ADDENDUM

Project: Syracuse South Stake Suite

Project No.: 570-0280-24010301

Addendum No.: 01

DEMOLITION ROOF PLAN
AND NEW ROOF PLAN

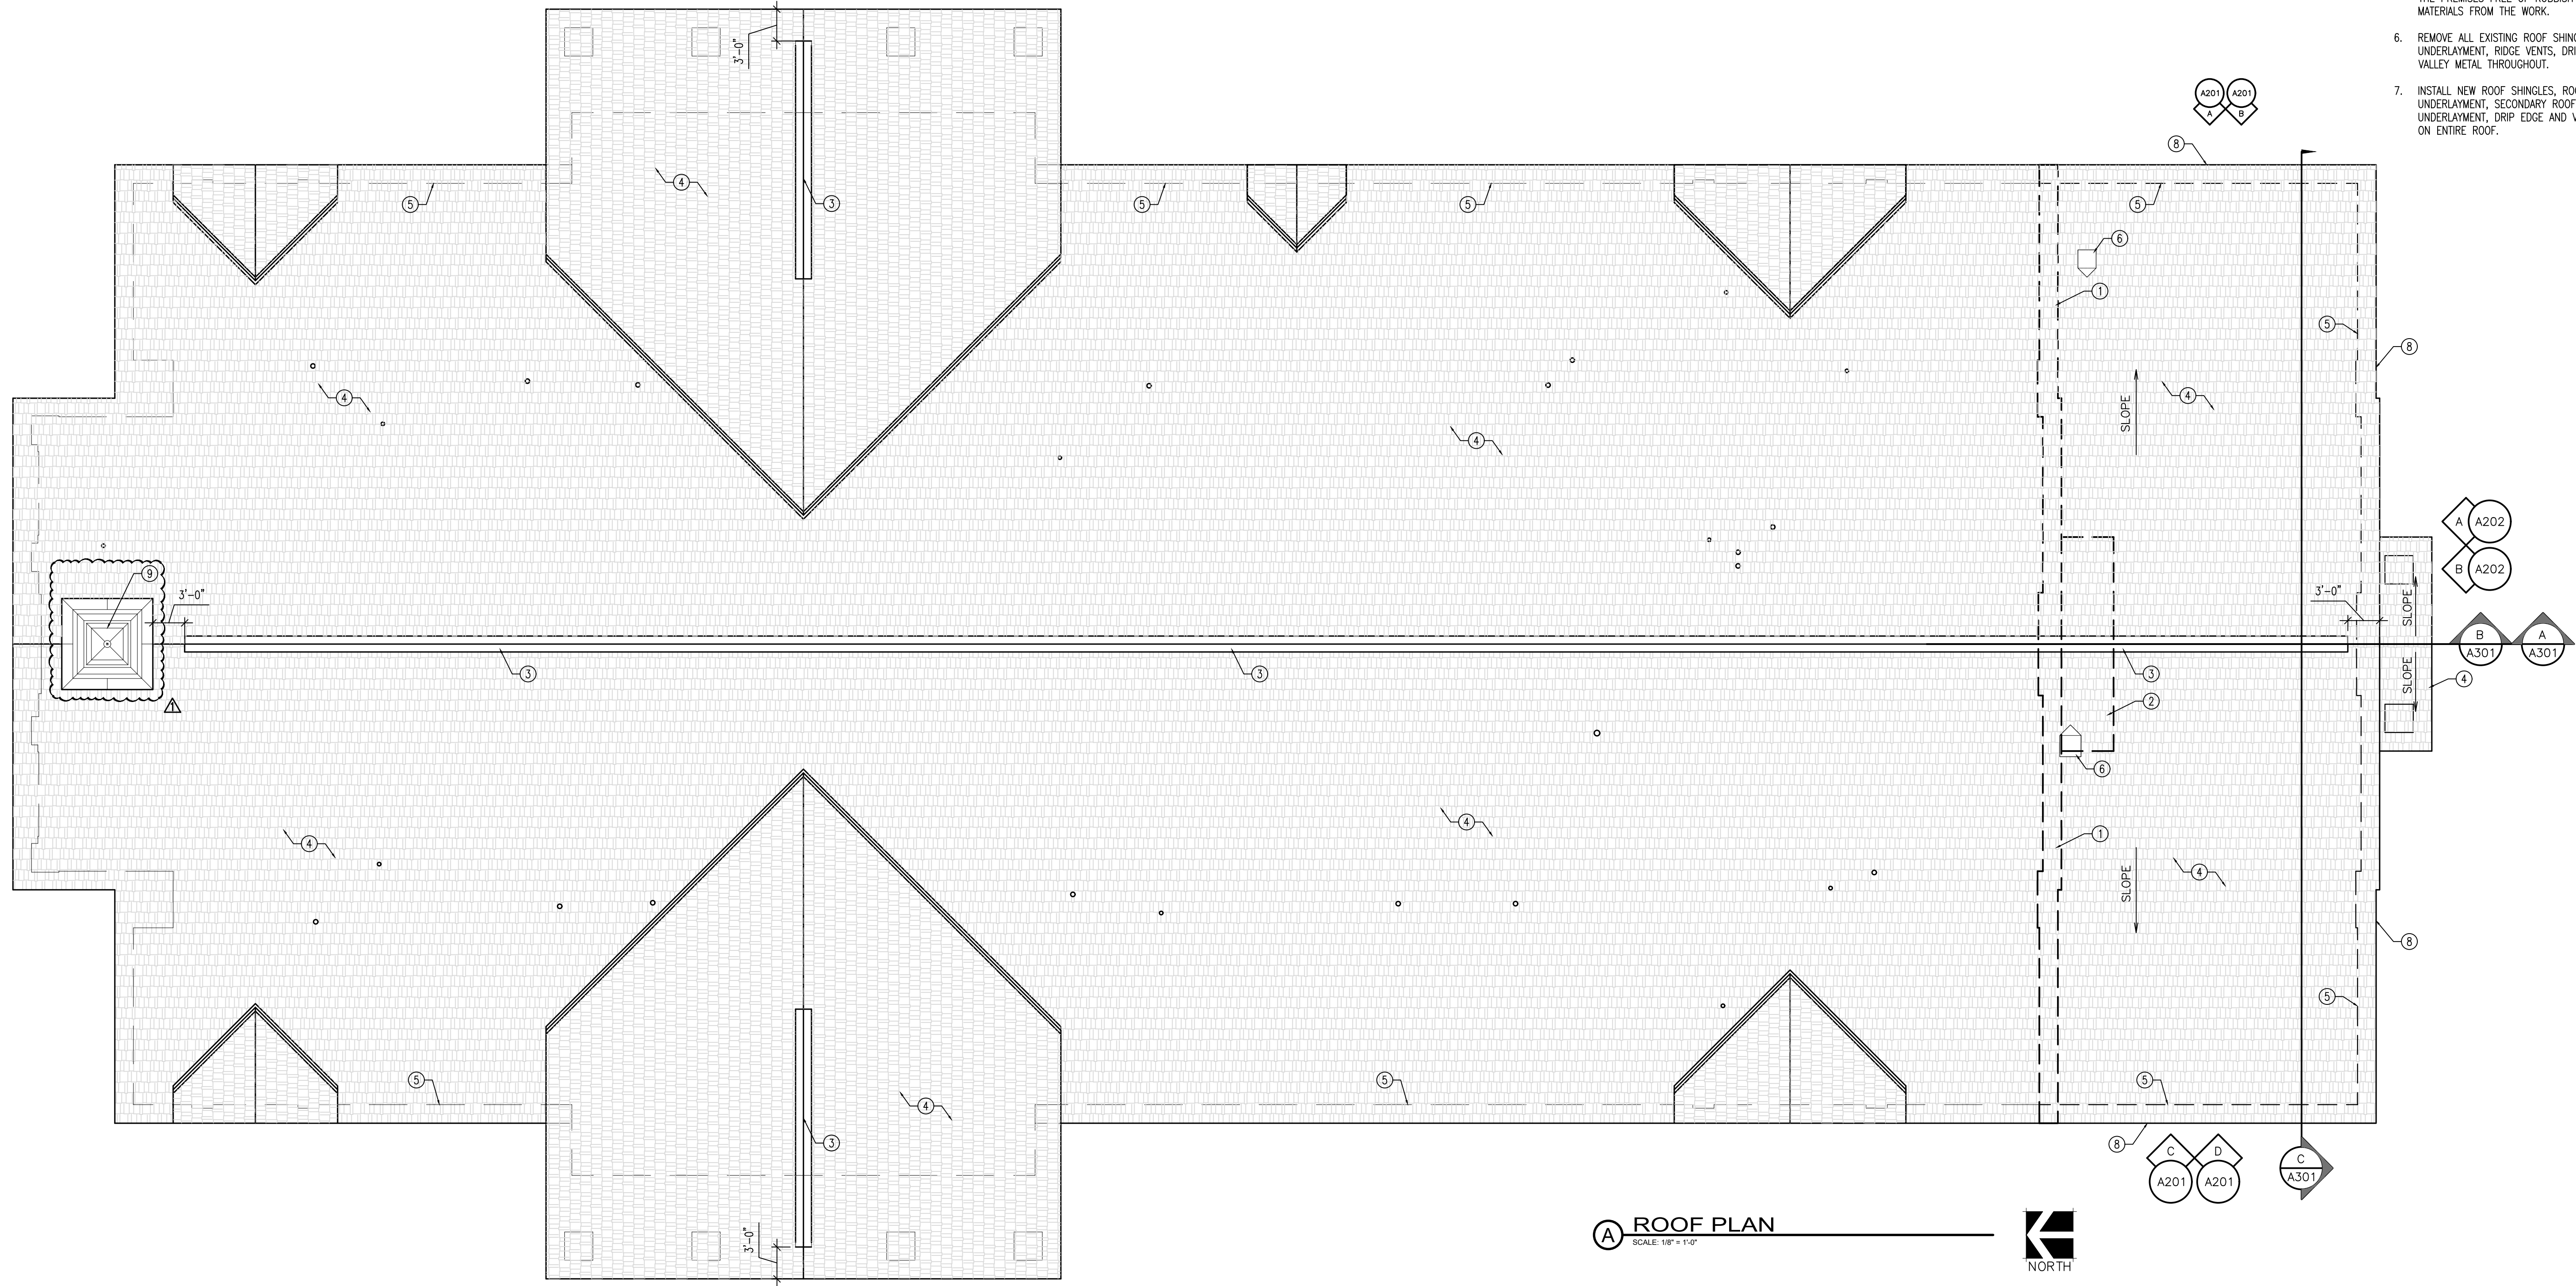
a. A121 Demolition Roof Plan and New Roof Plan

The attached revised plan shall be added to the contract documents.
